DRAINAGE CERTIFICATION

GRADING PLAN

Re: Sierra Platinum Apartments
4100 Silver Ave NE
Request for Permanent C.O. – Not Accepted
Engineer's Stamp dated: 5-12-14 (K17D108)
Certification dated: 7-17-15

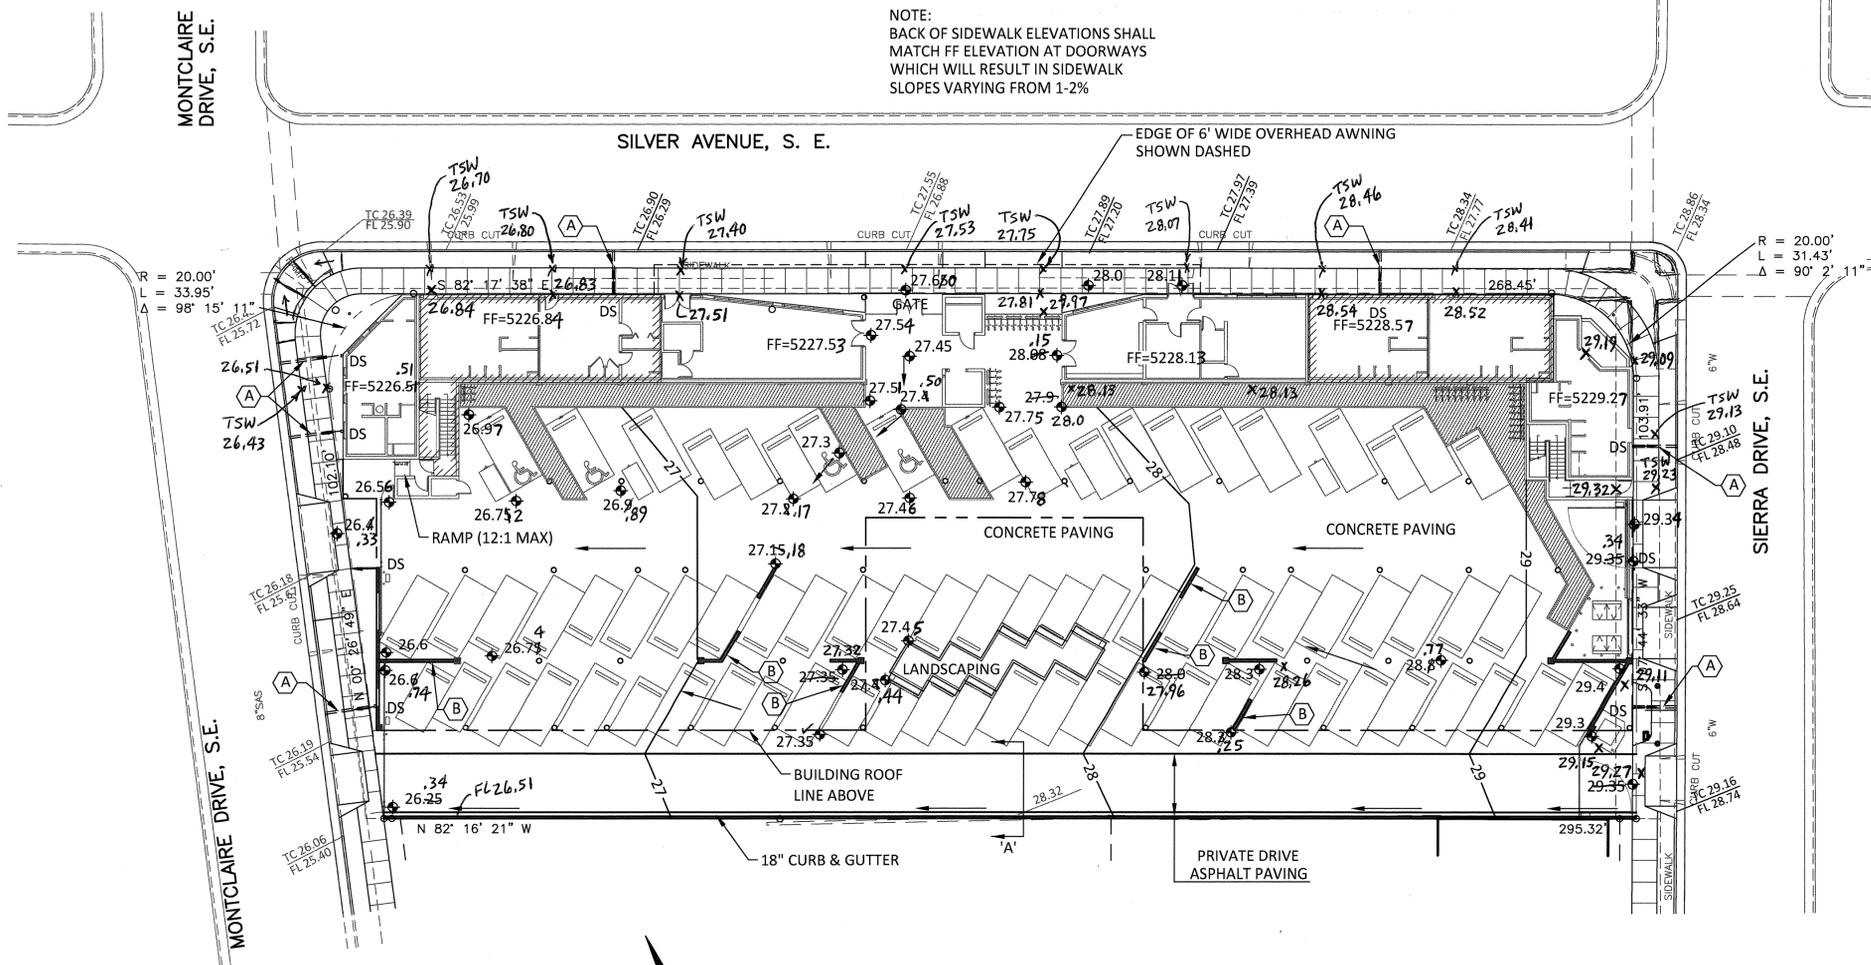
Based on the Certification received on 7/20/2015, the Sierra Platinum Apartments are not acceptable for release of Certificate of Occupancy by Hydrology. The sidewalk culverts were not approved by Jason Rodriguez and the cutouts in the walls were not provided.

In the new plan being submitted provide roof flows and new calculations for the site.
